Planning and Zoning Board

Staff Report

CASE NUMBER: ZON18-00470
LOCATION/ADDRESS: The 200 block of North Signal Butte Road (east side) and the 10800 block of East Mercury Drive (south side).
GENERAL VICINITY: Located south of University Drive on the east side of Signal Butte Road
REQUEST: Rezoning from RS-9 to RSL-2.5-PAD; and Site Plan Review, also consider the preliminary plat for "Montelucia"
PURPOSE: This request will allow for the development of a single-residence subdivision
COUNCIL DISTRICT: District 5
OWNER: Funk Family Enterprises
APPLICANT: Mark Funk, Funk Family Enterprises
STAFF PLANNER: Cassidy Welch

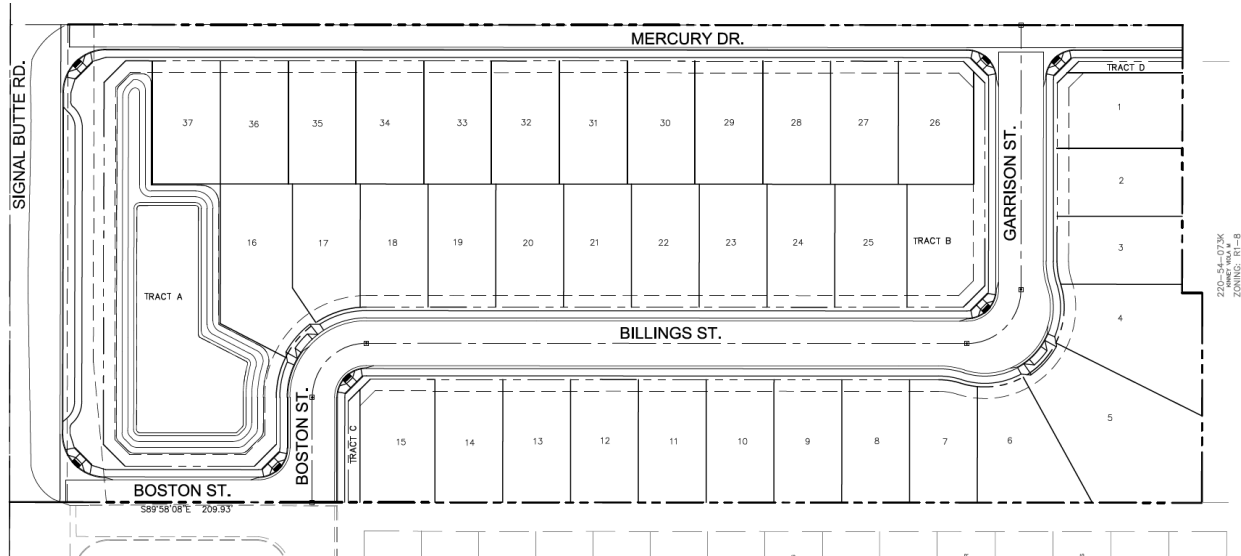
The application is proposing 4 floor plans with 3 elevations each. Below are examples of the included product design. Full elevations and floor plans are provided for Board review with the supplemental materials included in the Planning and Zoning Board packet.

Per section 11-5-3.E, a façade articulation waiver may be requested for the requirement to set the garage façade back 3' from the primary wall. Façade articulation waivers can only be approved for subdivisions with more than 25 lots and is only applicable to a maximum of 40% of the lots in the subdivision. The façade articulation would apply to a maximum of 14 of the proposed 37 lots in the development. The application is requesting a façade articulation for the "Spanish Colonial" elevation of 3 floor plans. The design of the "Spanish Colonial" elevations makes it difficult to extend the entryway without creating awkward and unusable space. Due to the high-quality architectural design and use of real materials, staff has no concerns with the proposed façade articulation.
